18 February 2019

RE: Bylaw 13P2019 and associated land use amendment application LOC2018-0193,  
and the related bylaw 42D2019 (CPC2018-1363) affecting 4303 16 St SW

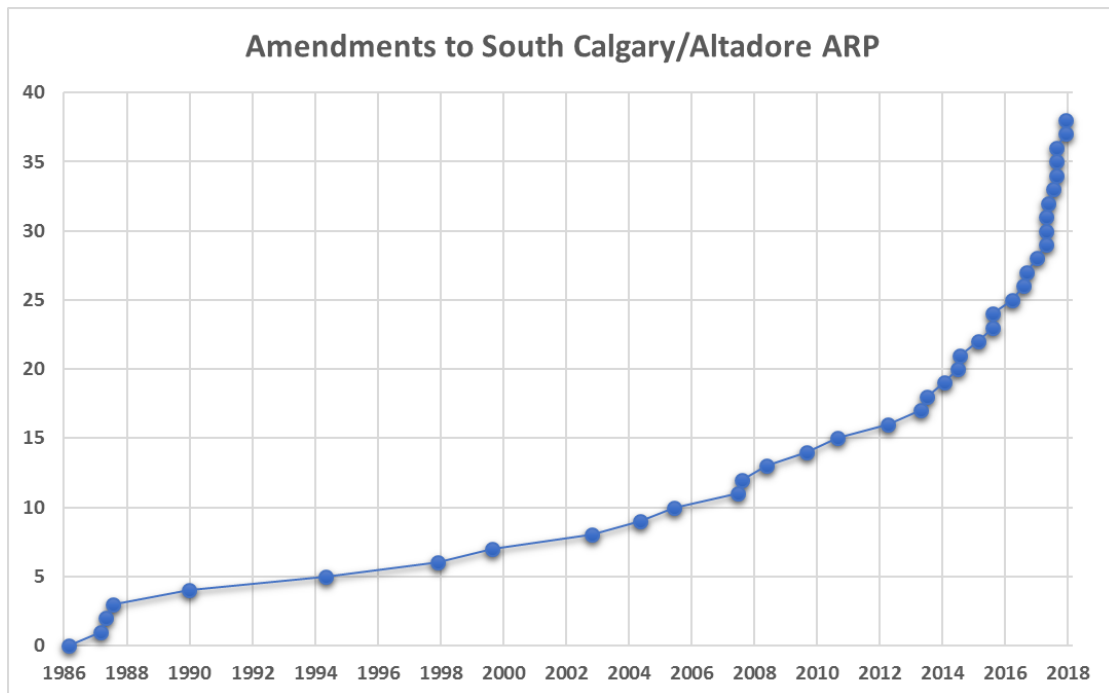
1. The CPC Report does not clearly address any planning alternatives for the site, stating that "the proposal allows for a range of building types that have the ability to be compatible with the established building form of the existing neighbourhood". However, the Developer's submission (in Attachment 1 of the CPC Report) clearly states the intention to build a 6-unit rowhouse. The CPC Report is deficient in that it does not address whether this specified building type is compatible with the "established building

form of the existing neighbourhood". We contend that this specified intent is not a compatible form when compared to any of the established building types within 250m of the subject property in any direction – approximately 275 comparable established dwellings within the area in the diagram below. Not one of these comparable dwellings is a rowhouse.
